Service Kit 753-05851

Subject: Service Replacement for the
618-04034 Single Speed Transmission

Supplement Sheet

Subject: Torque Bracket Rework

FIGURE 2

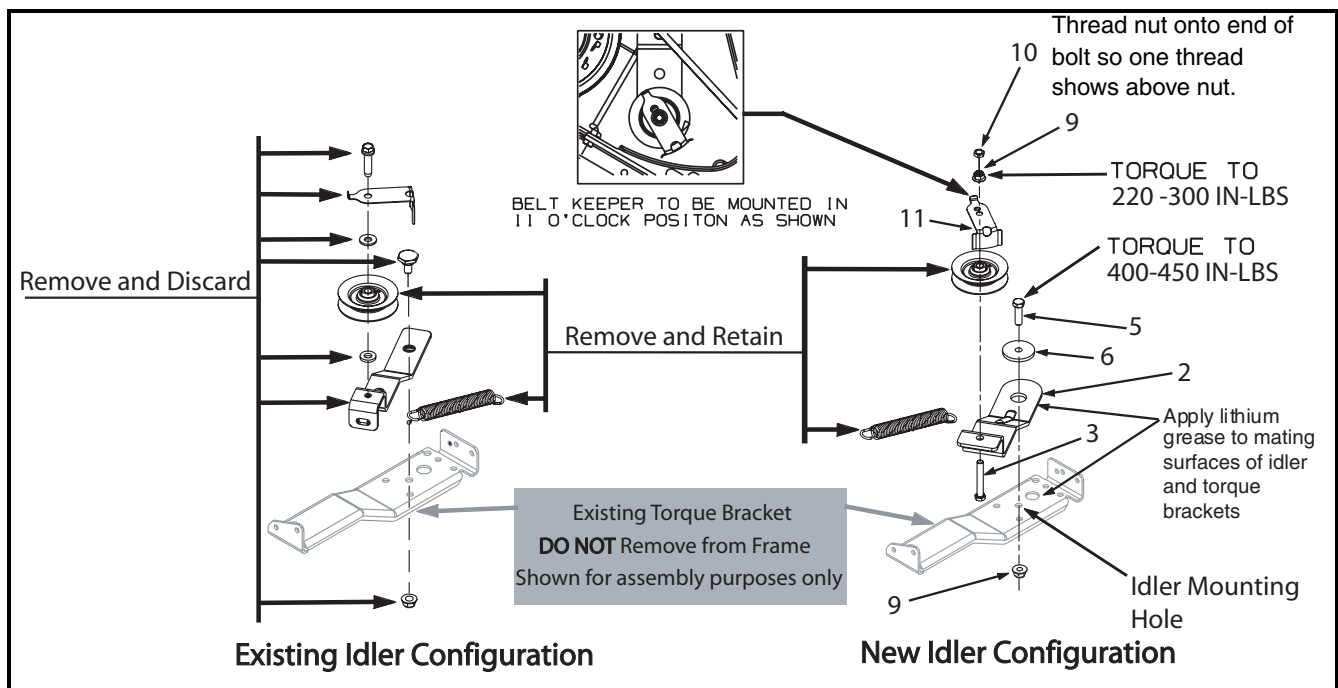
12. Inspect the existing idler bracket configuration. Referring to Figure 2, if the existing idler bracket is similar to that shown in the **Existing Idler Configuration**, proceed to Step 13.

If the existing idler bracket configuration is similar to that shown in the **New Idler Configuration**, the idler bracket and spring mount have already been installed. STOP HERE.

14. Refer to Figure 2. Following the instructions within Figure 2, re-configure the upper transmission drive belt idler assembly as shown by the New Idler Configuration using the new hardware supplied and that retained as instructed.

FIGURE 1

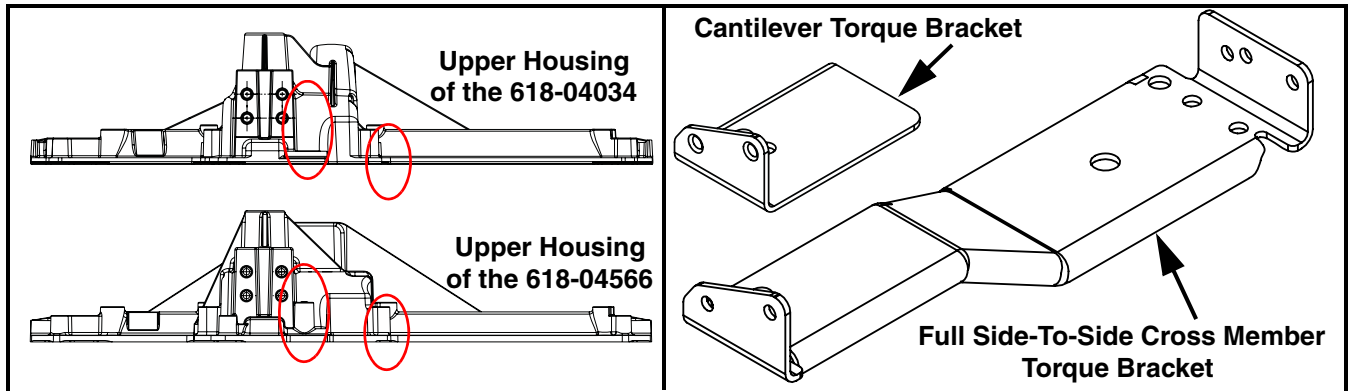
The configuration of the upper housing of the new 618-04566 transmission (See Figure 1) will interfere with the cross member torque bracket at two points. This results in the transmission not seating onto the frame at its mounting points.

1. Lawn tractor is a 600 Series AutoDrive, Transmatic or Shift-On-the-Go (non-hydrostatic transmissions) model
2. The existing transmission, being replaced, is a single speed 618-04034. See area of concern in Figure 1.
3. The existing torque bracket is a full side-to-side cross member style as shown in Figure 2.

FIGURE 3

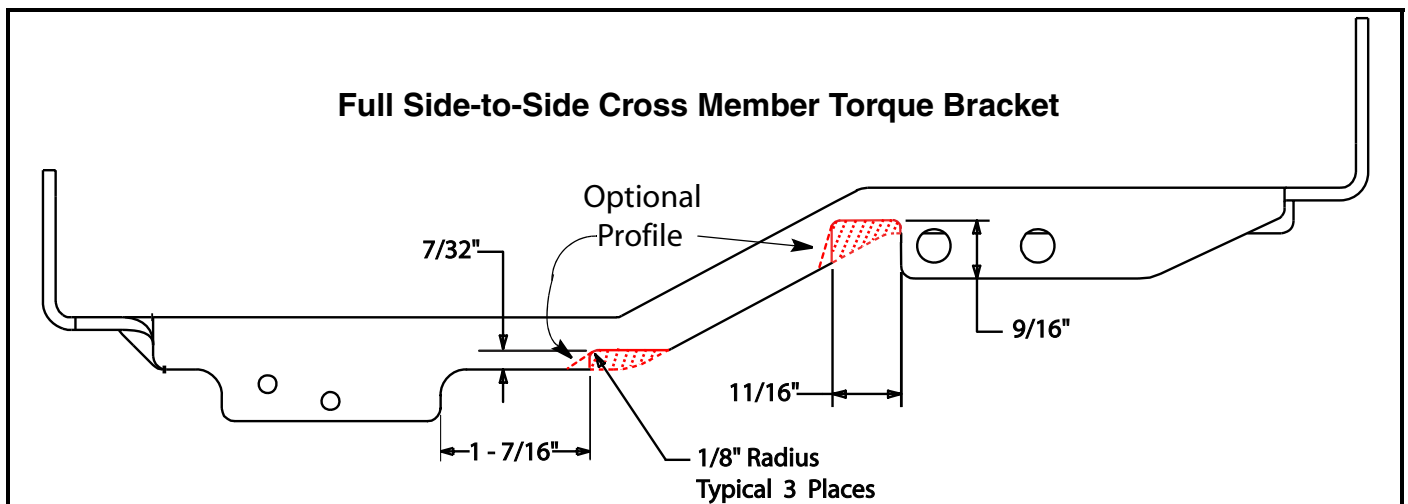
1. With the transmission removed from the lawn tractor, mark the cross member as shown in red in Figure 3.

2. Using a 4-1/2" hand held angle grinder with a 4" abrasive cutoff disk, remove the torque bracket material shown in red in Figure 3. Remove the material slowly so as not to over heat the part.
3. Remove any burrs or sharp edges with a file. Use a primer/sealer to cover the exposed metal.
